Informal document **GRSG-115-33**
(115th GRSG, 09-12 October 2018,
agenda item 6(b))

Regulation on Blind Spot Information System for the Detection of Bicycles

Introduction and Summary of Changes from IWG VRU-Proxi

Modifications – Function

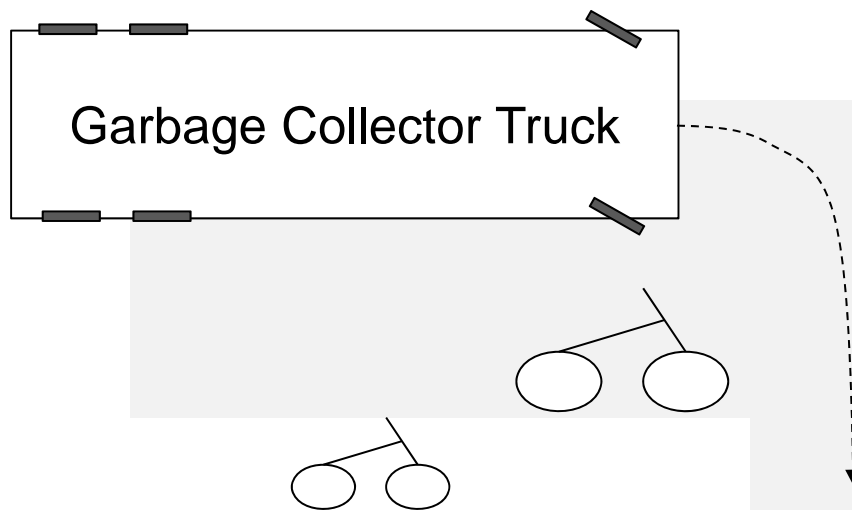
Optical information signal

- > 30° to the right of the driver
- Only automatic deactivation (ice, snow on sensors, ...)

Additional warning signal

- Different to information signal
- Activation strategy decided by Vehicle Manufacturer
- not before collision becomes imminent

Motivation for Warning Signal: Multiple Cyclists

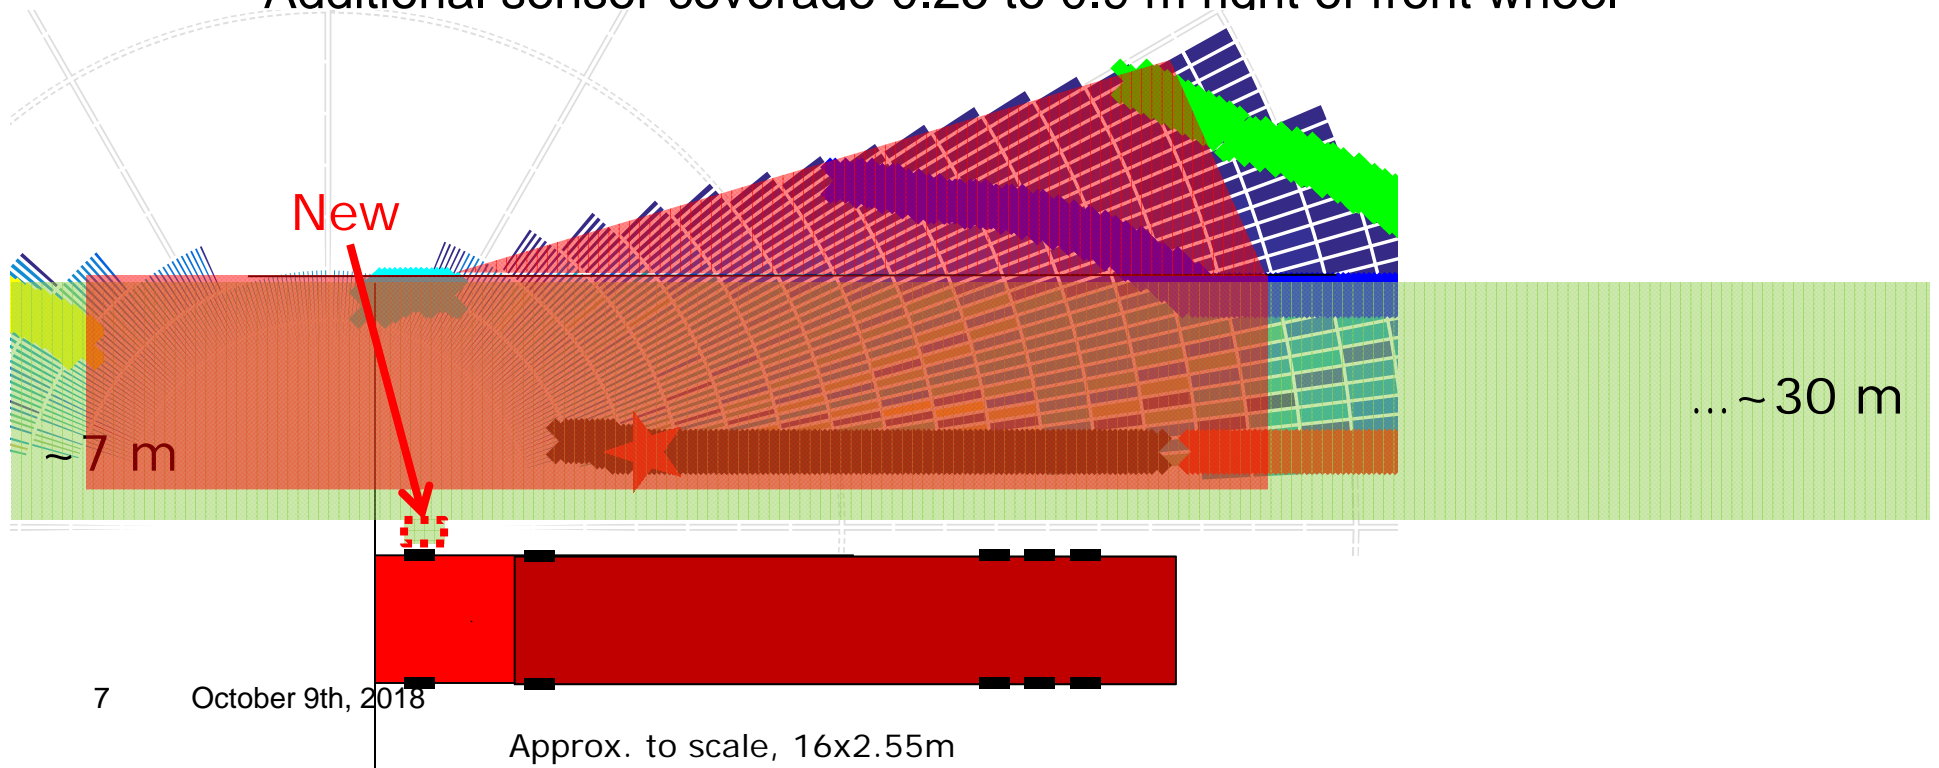
- Truck driver stops, gives way to adult bicyclist
- **Does not see child on sidewalk**

- Information signal would have been activated for both cycles
- No differentiation for second bicycle possible

- Additional Warning would have been triggered when collision becomes imminent
- When truck starts to move!

Impressions: Bicycle 30 m @ TTC=5 seconds

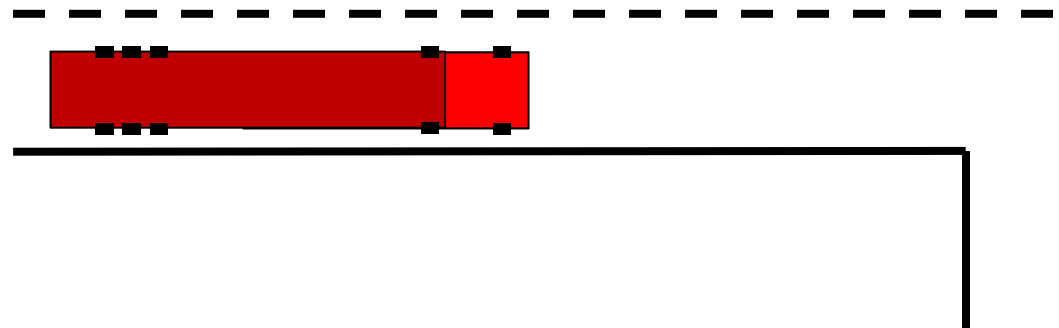
- Dynamic test cases
 - Tests conducted without actual turn manoeuvre
→ *Test conduction simplified: Reduction from 12 to 7*
 - Information signal required 15 m before collision point
(data shows turning manoeuvre starts not before 15 m)
→ *Requirements **NOT** simplified!*
 - Information signal not too early
 - Tests outside of test case table possible
- **New:** Additional static test cases
 - Vehicle stopped before roundabout
 - Vehicle stopped at intersection
- Cyclist Dummy: Reference to ISO [WD] 19206-4
- BSIS System should work with 36% smaller dummy-bicycle-combinations as well

- System Operation Requirements
 - Coverage starts at 0.9 m separation
- Tests without turning: Early information
 - Longitudinal coverage area increased to 30 m (rear)
 - Lateral coverage area reduced to 4.25 m (side)
- Additional sensor coverage 0.25 to 0.9 m right of front wheel
